For discussion on 24 April 2006

Legislative Council Panel on Environmental Affairs Tung Chung - Ngong Ping Cable Car Project

東涌吊車工程環境保護建議書 保護昂平珍貴生態資源

立法會陳偉業議員 2006年3月10日

附圖三:樹木的樹枝被不適當地砍去,承建商 又沒有妥善修復樹枝被砍去後出現的破口,使 樹木容易被細菌及真菌感染。

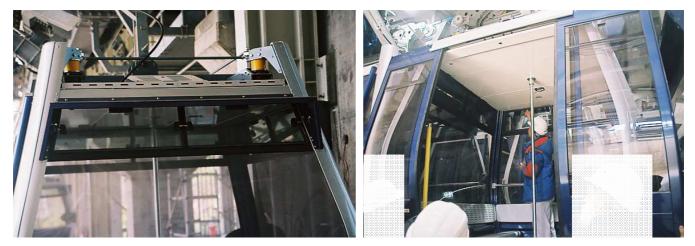
- 2.1.2.2 承建商為了補償因工程而填平的溪流,建造了一條人造溪流。為此,承建商砍去百多棵樹木。另外,在珍貴樹木旁邊並無放置警告牌或圍欄,承建商任由大型建築物料和垃圾,如廢棄的鋼纜捲筒等,放置在樹木旁和植被上(見附圖一、二)。這些重物均會壓毀樹幹及樹根,對植被造成損害。此外,工程中將一些索緊了的鋼纜靠著樹幹,樹幹因此而受到破壞。工程進行期間,承建商更把部份樹木的樹枝砍去,但由於採用不適當的方法砍去樹枝,在砍去樹枝後又沒有妥善修復樹木受損的部份,因而使細菌、真菌或昆蟲輕易透過樹枝的破口侵食樹幹內部,對樹木構成威脅(見附圖三)。而承建商在遷移受工程影響的植物時,有接近六成被搬遷的植物死亡,更有不少珍貴的自然植物被偷去或失蹤,當中更包括在中國受保護的自然植物,例如中國吊鐘等。由於承建商的疏忽,導致了珍貴樹木的大量死亡和損傷,造成不可補救的結果。
- 2.1.2.3 基於上述原因,在工程附近的樹木遭遇到不可補救的損害。

- 8.2.2 Trees Removed for Stream Construction Works To comply with the EP conditions, MTRCL has to plant not less than 600 trees near the new streams and also, to plant new trees in an area of not less than 1 ha. within the Lantau North Country Park. Trees of reasonable health, of reasonable form and with a reasonable chance of surviving the shock of transplanting had been transplanted as far as possible. In this regard, MTRCL has generally observed these conditions.
